BEACH AVENUE  
Long Island

# Berntum Camp

Subject: Application for building permit to move  
one story frame cottage from Marsh Island to  
a certain lot on Beach Avenue, Long Island

Beach Ave., Long Island - To move small cottage from Marsh Island to the Bernstein lot on Beach Ave., Long Island - 5/15/44

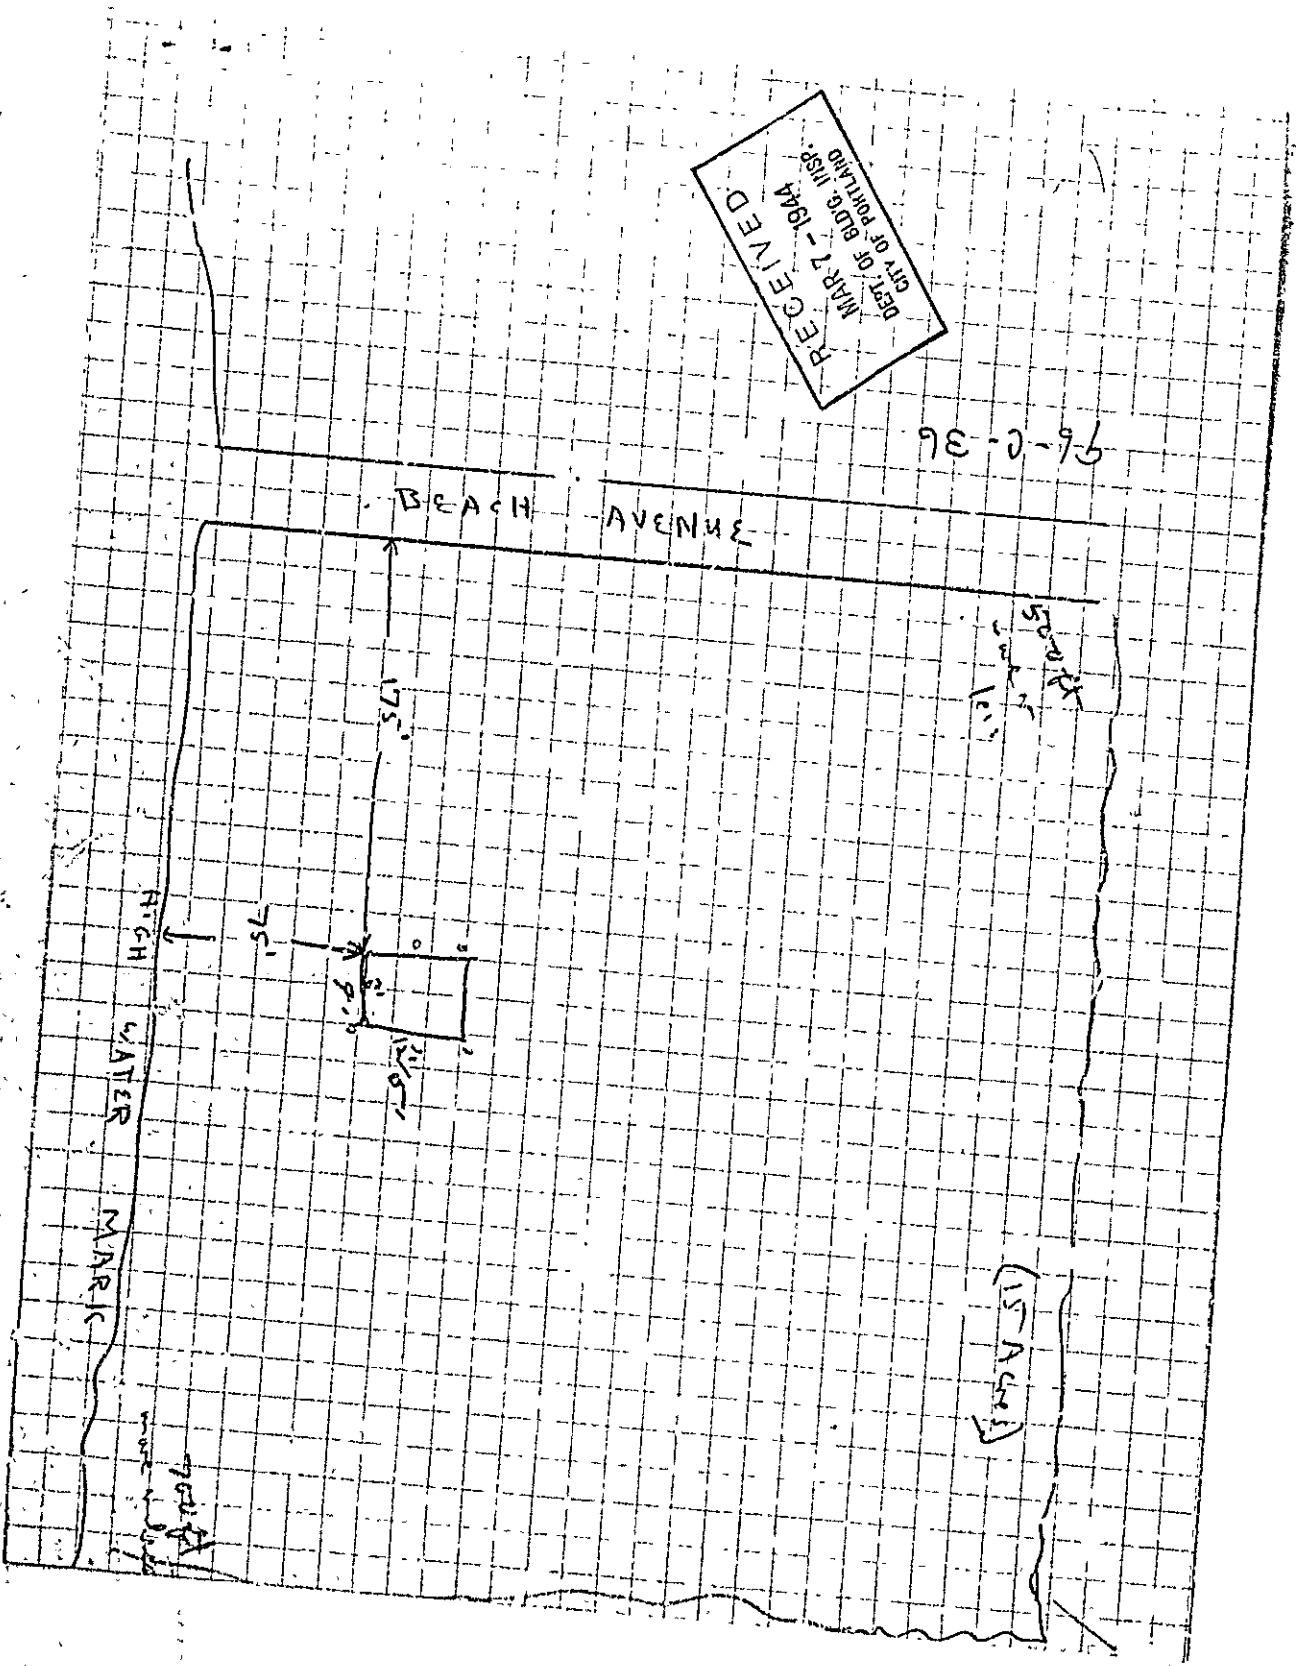
To Owner and Contractor: Since the rafters are 50 inches from center to center, it is necessary that additional rafters be provided between each existing pair, thus the rafters would be 15 inches from center to center. These rafters must be cut in in a careful workmanlike manner so that they will actually help to support the roof boards not just to satisfy some precise requirement of the law. If any of the existing rafters get their bearing between the studs beneath the plate in the exterior walls, it will be necessary to reinforce the plate since it is evidently only a single 2x4.
